**Service Bulletins
January 1979 to
September 1986 inclusive**

**Rolls-Royce Silver Shadow
Long Wheelbase,
Corniche and Camargue
Bentley T Series and Corniche
Rolls-Royce Silver Shadow II
and Silver Wraith II
Bentley T2**

ALL ROLLS-ROYCE FRANCHISE HOLDERS
SERVICE BULLETIN INDEX FOR TSD 4318

Fig. 1

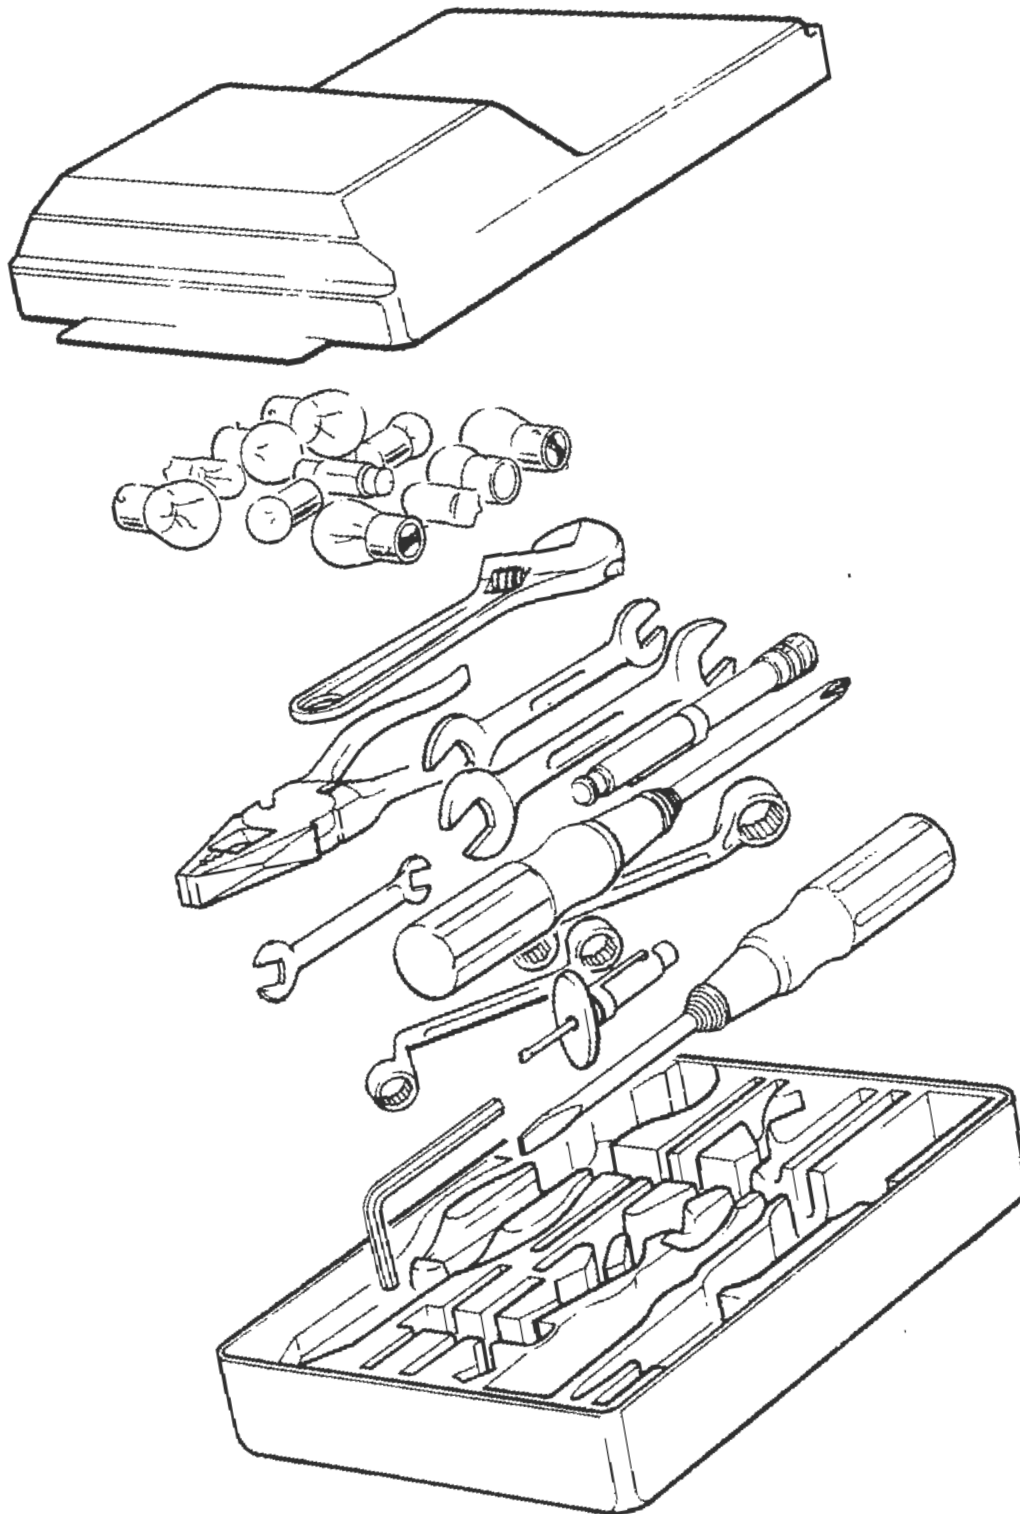
A revised hand tool kit as illustrated in Figure 1 has been introduced on all Rolls-Royce and Bentley motor cars from the above car serial numbers:

Fig. 1 Vehicle Identification Number (VIN)

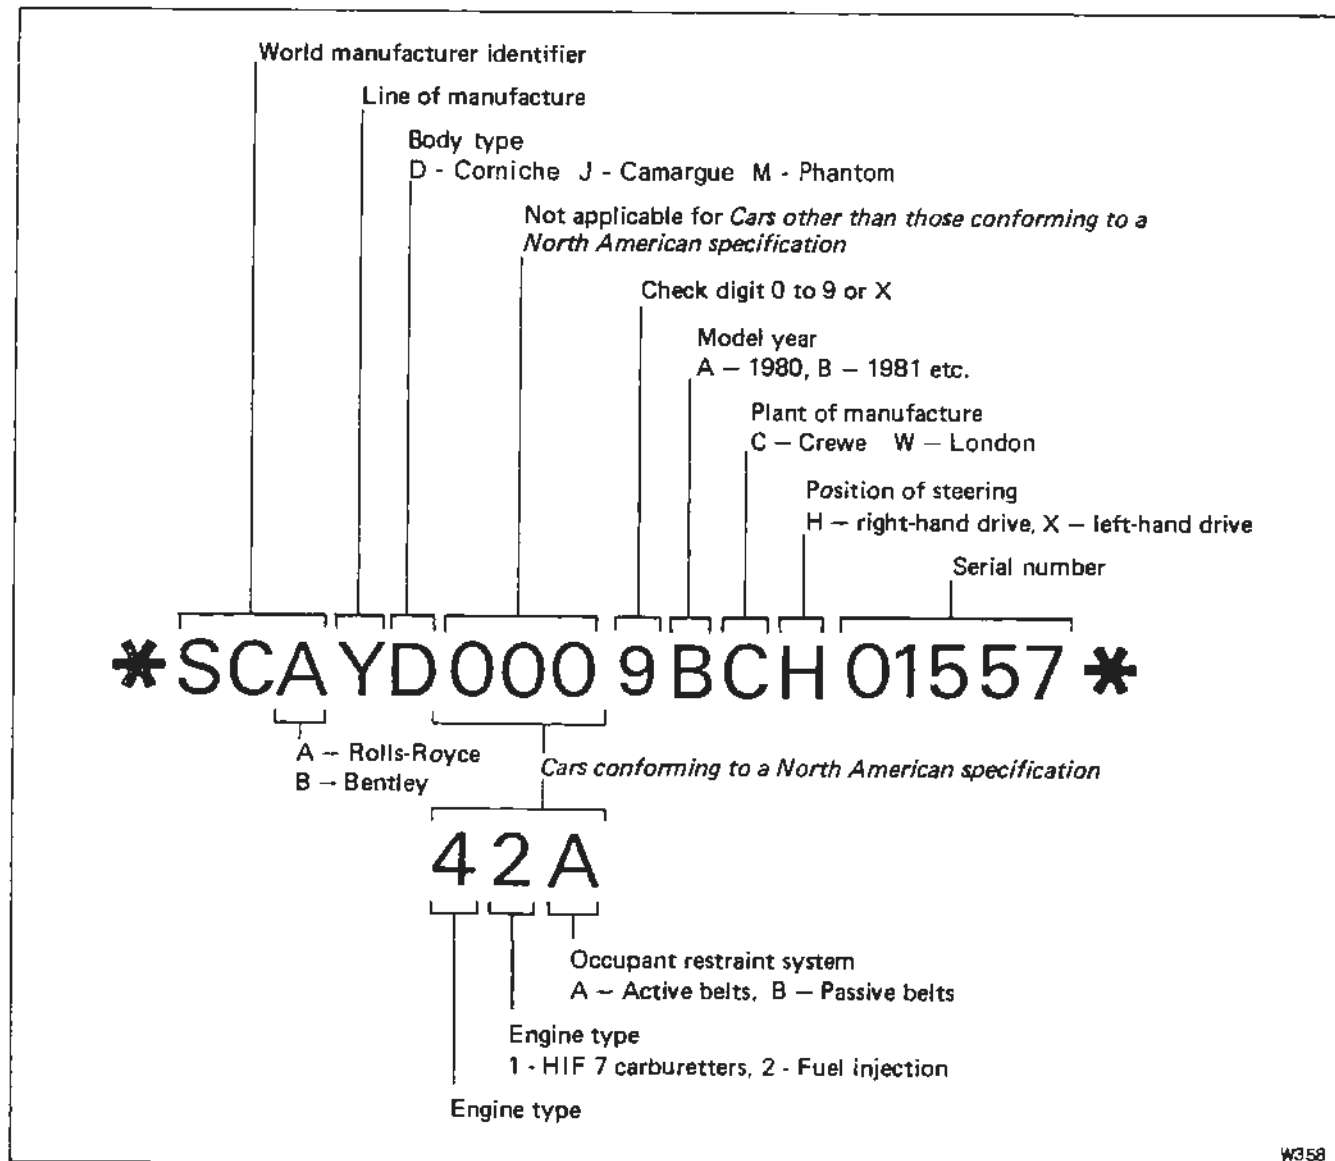
The vehicle identification number (VIN) consists of 17 digits as shown in Figure 1. The check digit is used for Factory checks on each vehicle identification number. This check digit varies according to the composition of the vehicle identification number.

Figure 1.

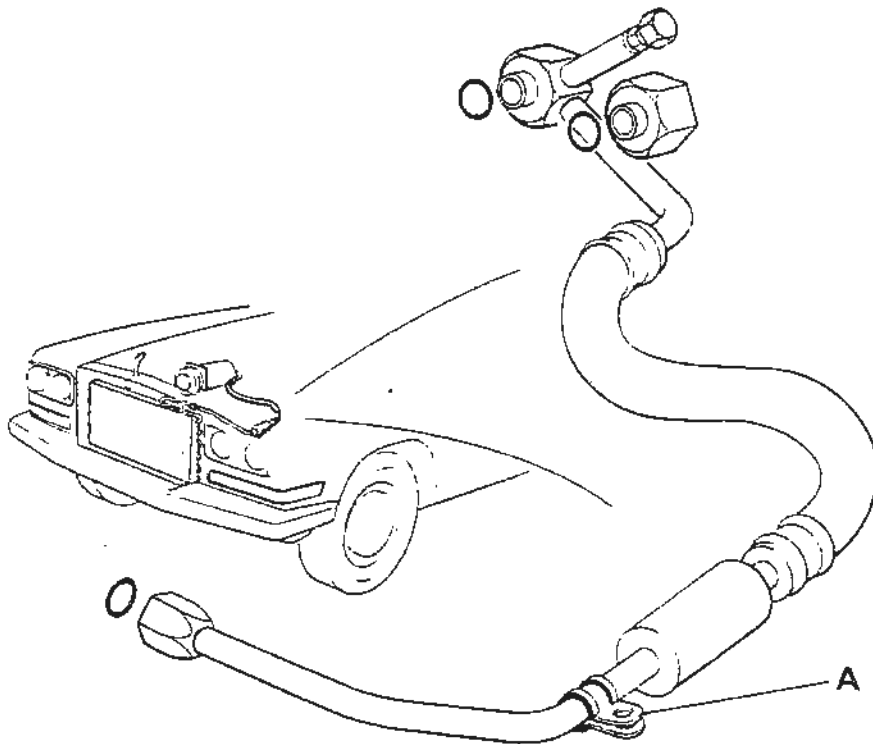
2. Remove the existing discharge hose (UD 20223) complete with 'O' rings and existing metal clip (fitted in position A in Figure 1).
3. Remove the existing 'O' ring from the suction hose, compressor end.
4. Fit a new 'O' ring (CD 4699) to the suction hose compressor end.
5. Fit a new 'O' ring to both ends of the silencer hose assembly. 'O' ring (UD 14799) to be fitted to the condensor matrix connection and 'O' ring (CD 4699) to be fitted to the compressor end.
6. Fit the silencer hose assembly (UD 22704) complete with 'O' rings and rubber lined clip (UR 14608). This clip replaces the metal clip (RE 14174) positioned at point A in Figure 1.
7. Charge the refrigeration system as instructed in TSD 4200 Workshop Manual - Chapter C - Section C2.

Fig. 1

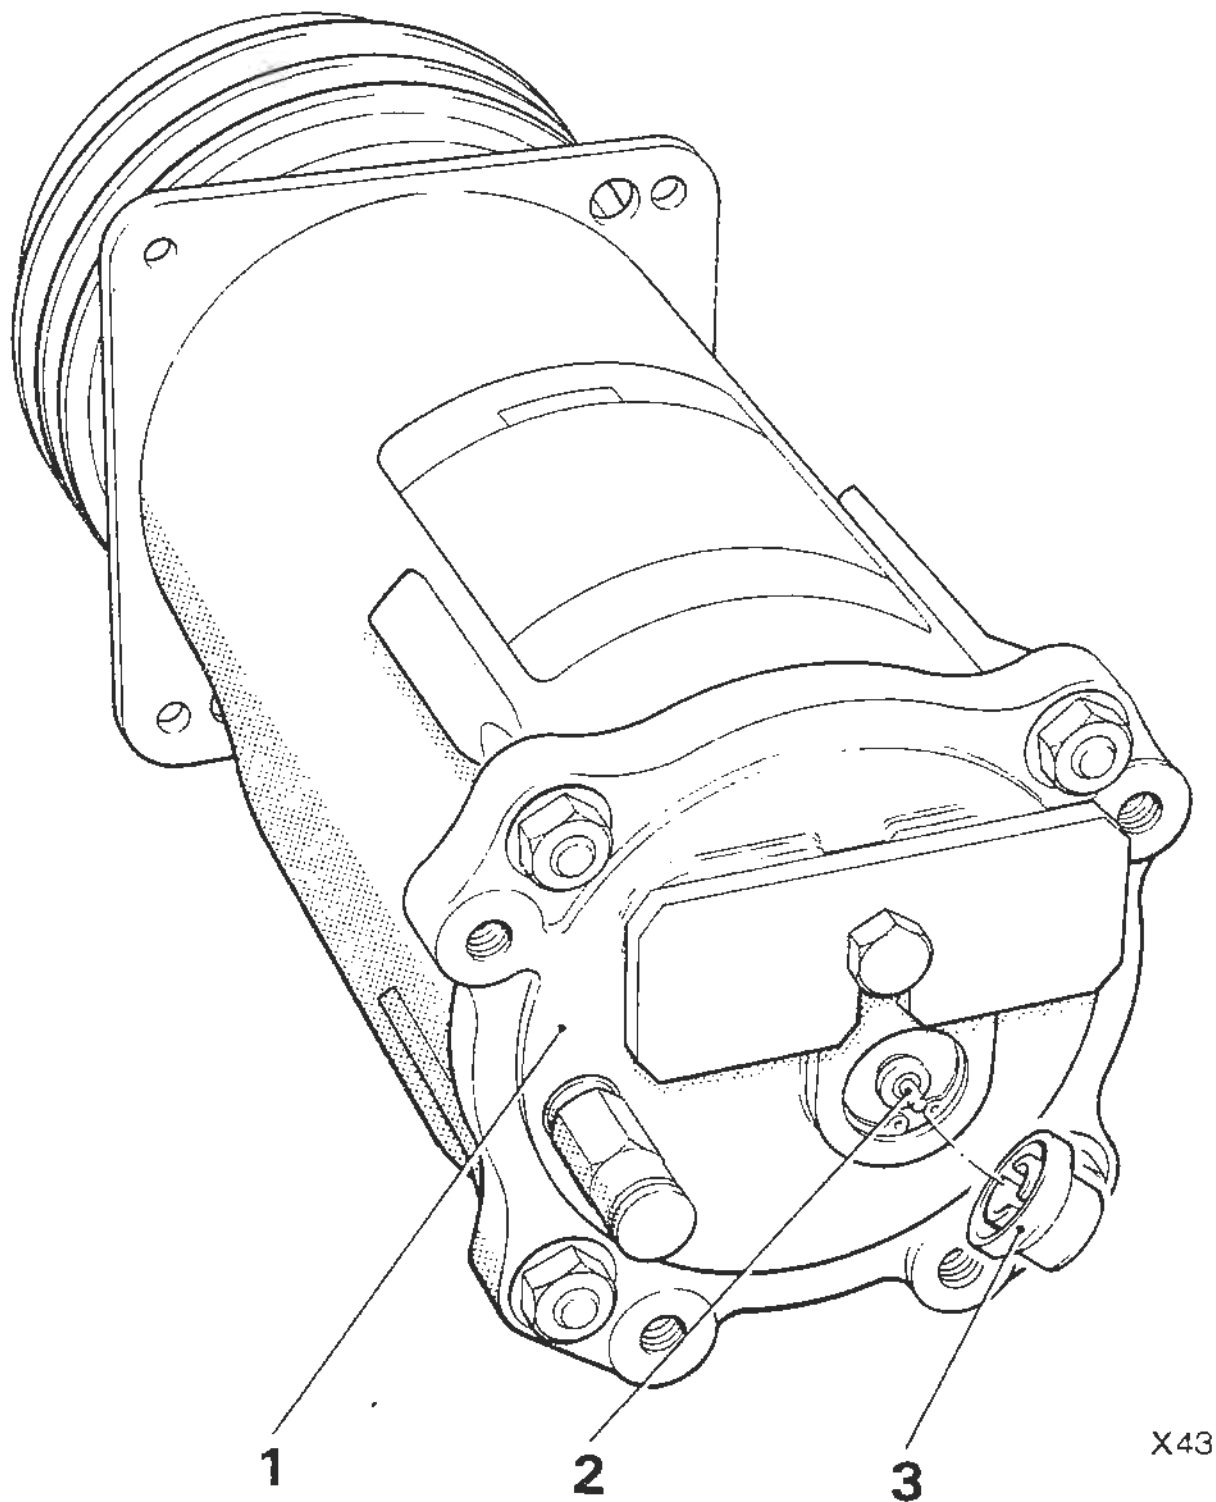
When first fitting a metric air conditioning compressor to one of the above motor cars, the protection cover must be removed from the superheat switch which is located on the rear head of the compressor (see figure 1). This cover must be removed to prevent the discharge pipe from fouling surrounding components.

Fig. 1

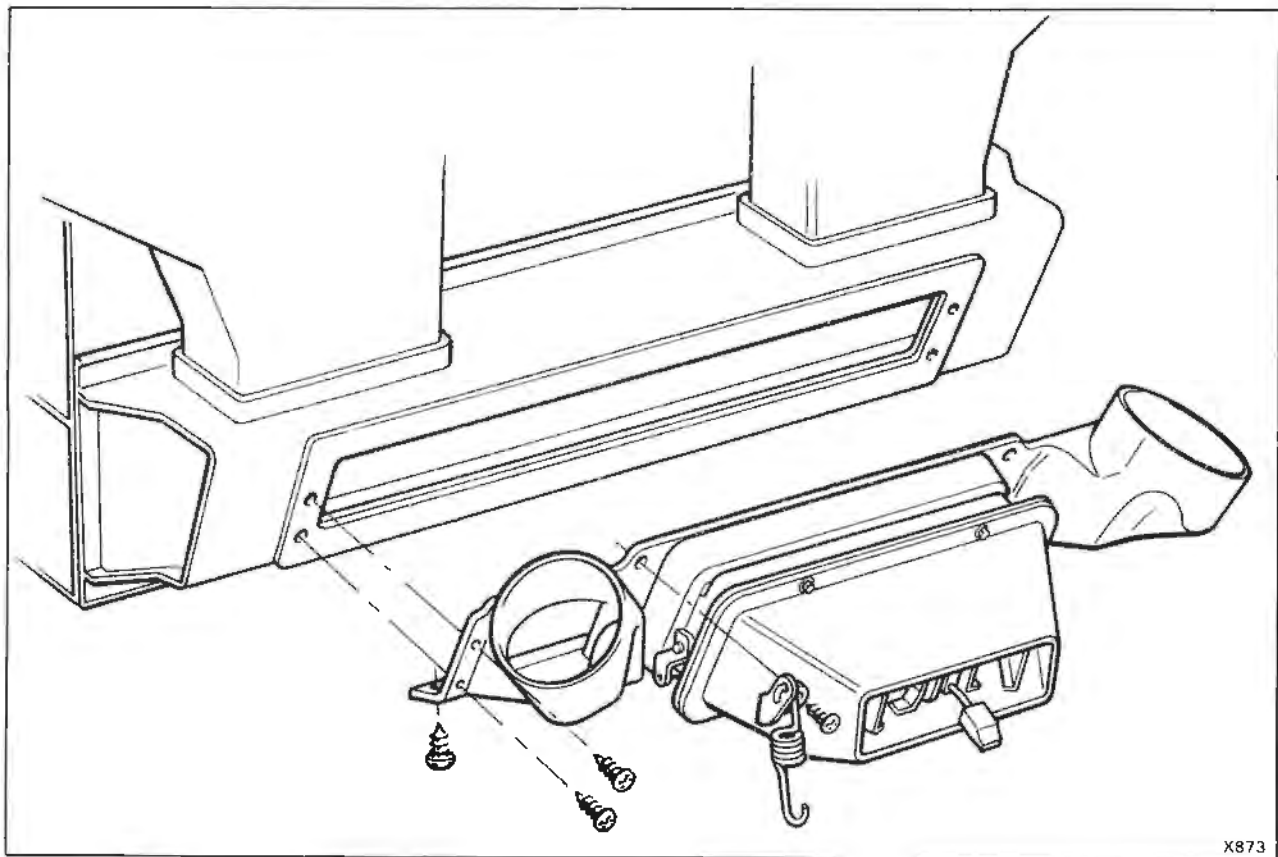
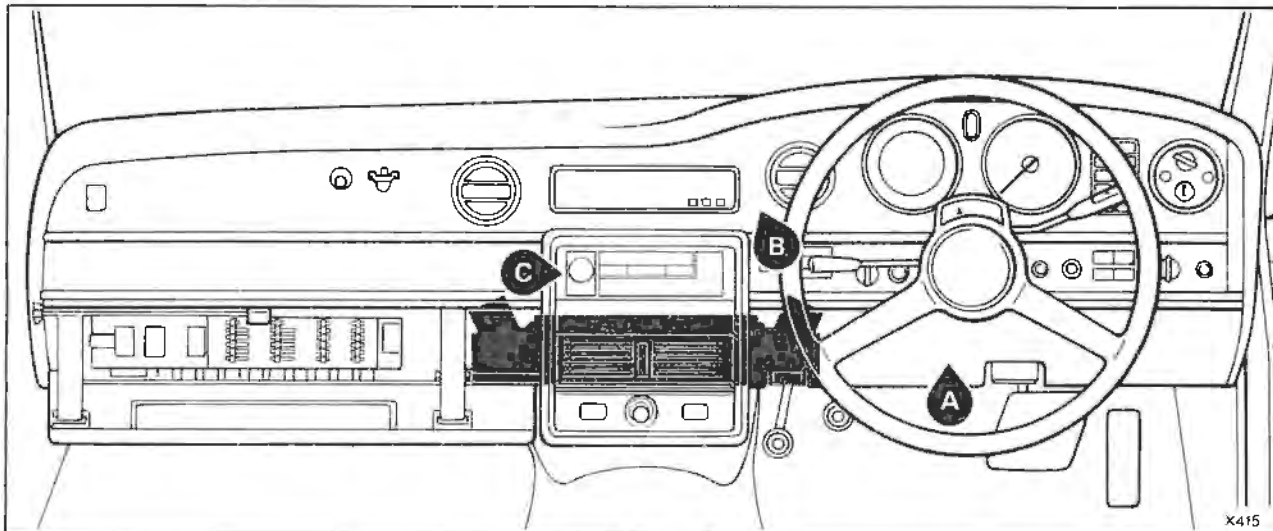
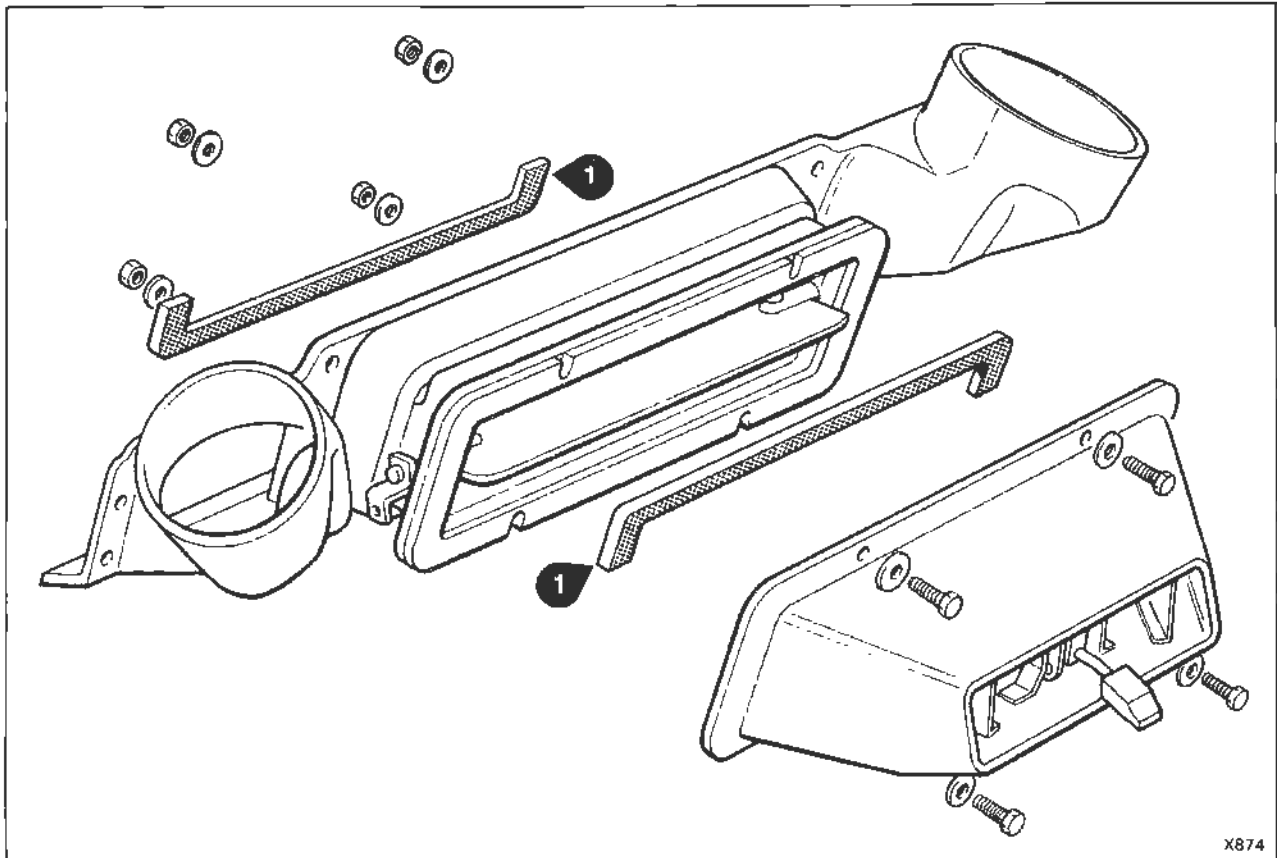
1. Disconnect the battery.
2. Remove the lower trim and facia panels (see fig. 1,A and B).
3. Remove the centre console (see fig. 1,C).
4. Remove the rectangular facia outlet and ducting from the main heater box assembly as shown in figure 1.
5. Remove the 4 nuts and bolts, disconnect the flap connecting the linkage and carefully separate the rectangular outlet duct from the flap housing (see fig. 2).
6. 'Free off' the rectangular flap and remove the original flap seals.
7. Fit the new self-adhesive seals.
8. Re-assemble the rectangular duct and flap housing and refit all components.

FIG 2

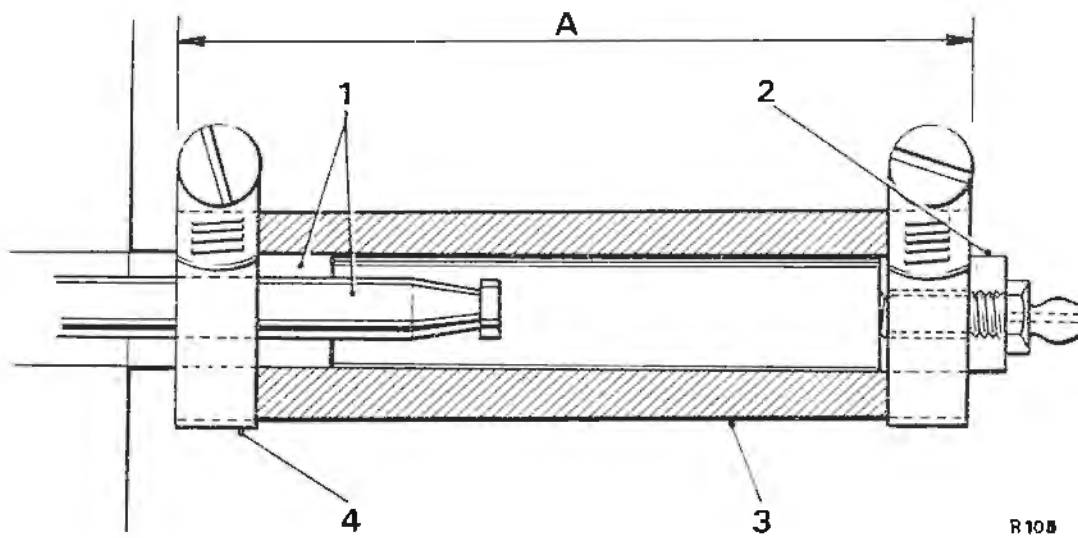
Essentially the tool is a short piece of thick walled rubber tube, see fig 2. A drilled and tapped plug fitted with a grease nipple is secured by a jubilee clip, the opposite end of the tube is secured by a jubilee clip to the valve guide. When fitted to the guide, the lubricant mixture can be forced down the guide/stem clearance with the aid of a grease gun.
